Access Compliance Report

Public Rights-of-Way

Intersection ID: 2499	Main Street: LAGRANDE_DR	Cross Street: HIGHLAND_CREEK_PY	Location: SE
ADA ID: E4E2769F26F1	Ramp Type: PerpDiag	Initial Pass/Fail: Fail	Overall Compliance: No
Severity Score: 10			
Codes/Mitigation Info/Possible Solution		Field Measurements/Component Compliance

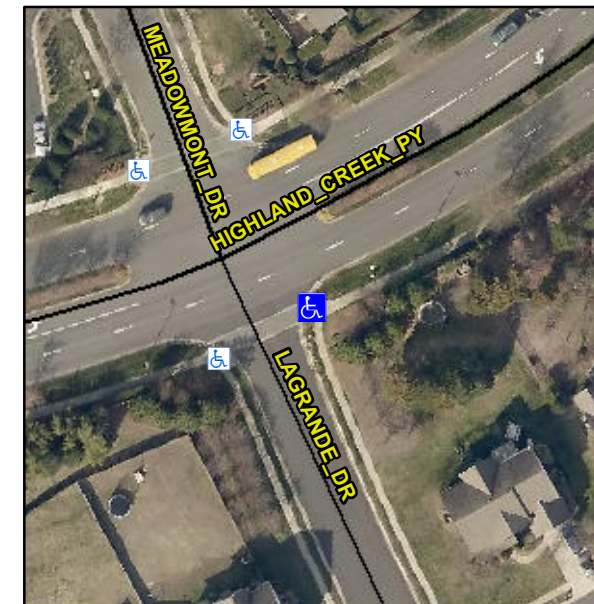
Compliance	Description	Data	Compliance	Description	Data
N/A	Ramp Length (in)	66.0	Yes	Ramp Slope (%)	7.8
No	Ramp Width (in)	38.5	No	Ramp XSlope (%)	4.1
N/A	Flare Type LT	N/A	N/A	Flare Type RT	N/A
N/A	Flare Slope LT (%)	N/A	N/A	Flare Slope RT (%)	N/A
N/A	Flare Traversable LT?	N/A	N/A	Flare Traversable RT?	N/A
N/A	Landing Length (in)	N/A	N/A	DWS Provided?	N/A
N/A	Landing Width (in)	N/A	N/A	DWS Contrast?	N/A
N/A	Landing Slope (%)	N/A	N/A	DWS Length (in)	N/A
N/A	Landing X Slope (%)	N/A	N/A	DWS Full Width?	N/A
N/A	Landing Curb? (Y/N)	N/A	N/A	DWS Offset (in)	N/A
N/A	Shared Landing?	N/A			
N/A	Gutter Ponding?	N/A	N/A	Gutter Slope (%)	N/A
N/A	Gutter Lip Ht (in)	N/A	N/A	Gutter X Slope (%)	N/A
N/A	Painted X Walk1?	No	N/A	Painted X Walk2?	Yes
	X Walk 1 Direction	To N		X Walk 2 Direction	To W
N/A	X Walk 1 Width (in)	N/A	N/A	X Walk 2 Width (in)	94.0
	X Walk 1 Slope (%)	4.6		X Walk 2 Slope (%)	0.5
	X Walk 1 X Slope (%)	1.1		X Walk 2 X Slope (%)	0.5

N/A	Ramp inside XWalk1?	N/A	N/A	Ramp inside XWalk2?	No
	Road Slope (%)	4.8	N/A	Clear Space?	N/A
	Road X Slope (%)	3.3	N/A	Clear Space to XWalk (in)	N/A
N/A	Any Obstructions?	N/A	N/A	Storm Grate/Utility Hazard?	N/A
	Obstruction Type			Storm Grate/Utility Type	
		N/A			N/A
		Yes		Surface Condition? (G/P)	Good

Remove & Replace Curb Ramp With Two New Directional Ramps or Equivalent. Restripe Crosswalk.
